# 22: Cross Section at White Oak Bayou Corte Transversal de White Oak Bayou

White Oak Bayou Greenway just north of Downtown, is a major asset to the City, providing much needed flood control features, recreational facilities, and ecological amenities. TxDOT's proposal extends well within the Greenway, diminishing its great qualities.

## TxDOT Proposal

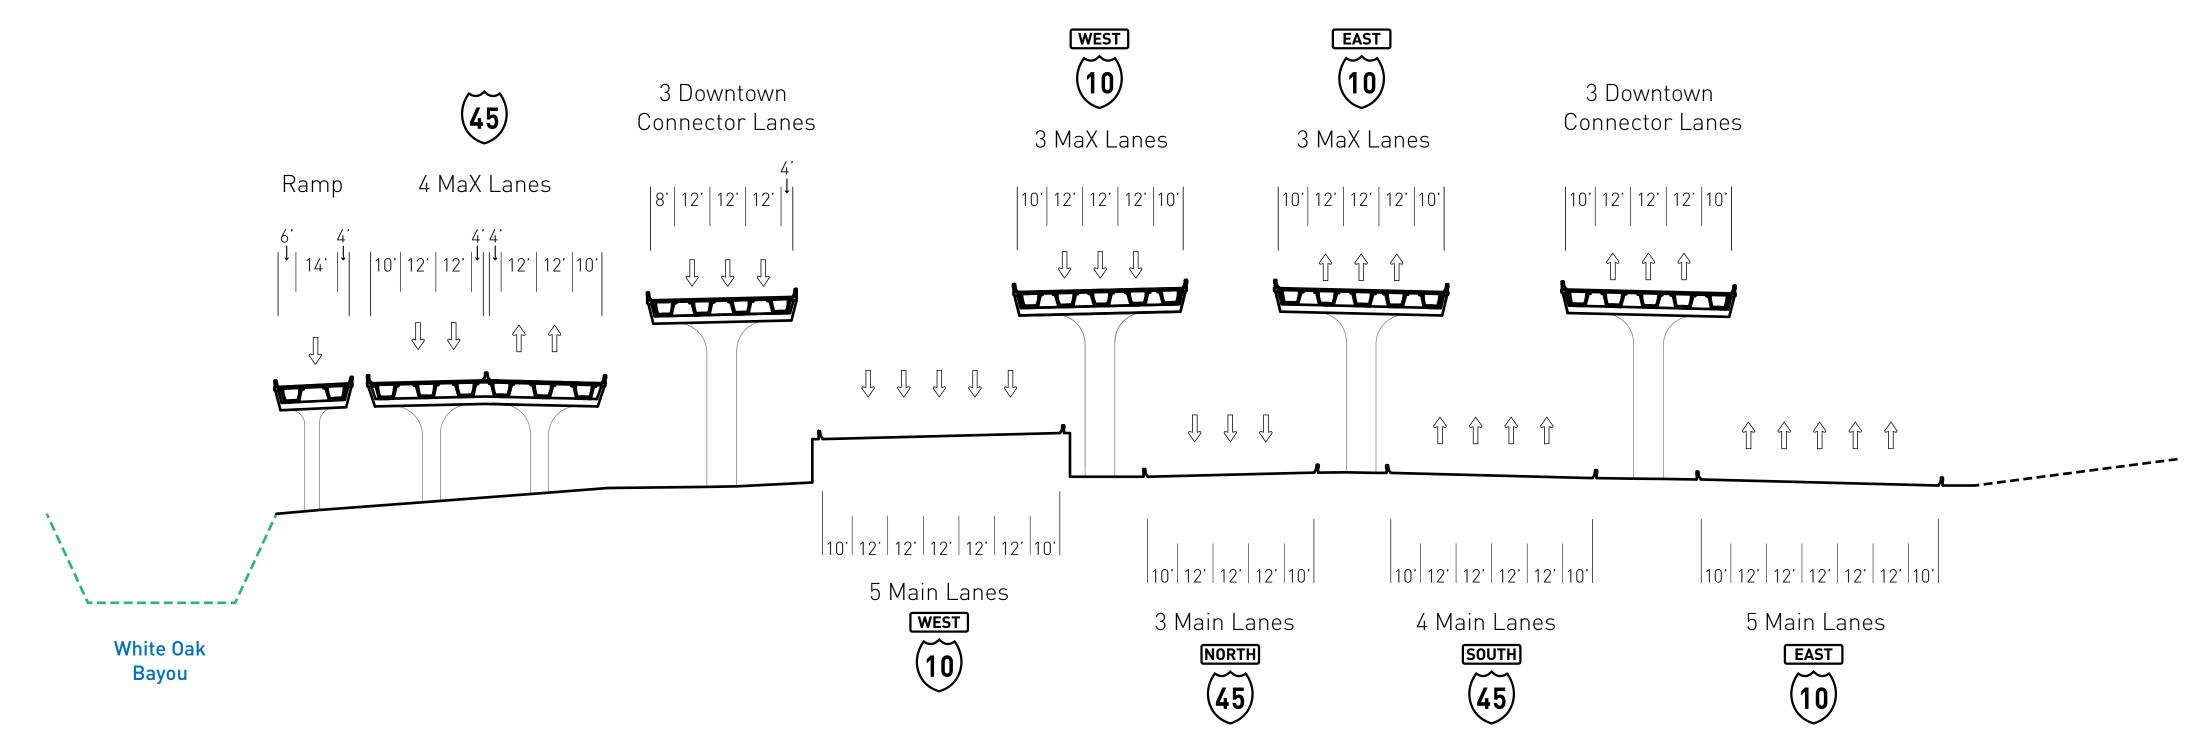
WOBA would like to express its concerns with respect to the potential for significant environmental impacts of the proposed reconstruction of I-45 on Houston's bayous and adjacent wetlands along the full reach of the project, and in particular on White Oak Bayou...

The project's design should mitigate for these impacts by incorporating vegetated detention basin, engineered wetlands and any other appropriate elements to reduce the flow rate into the bayous and remove pollutants.

- Ramps extend into White Oak Bayou Greenway, and add retaining walls and structures at the edge of the bayou channel
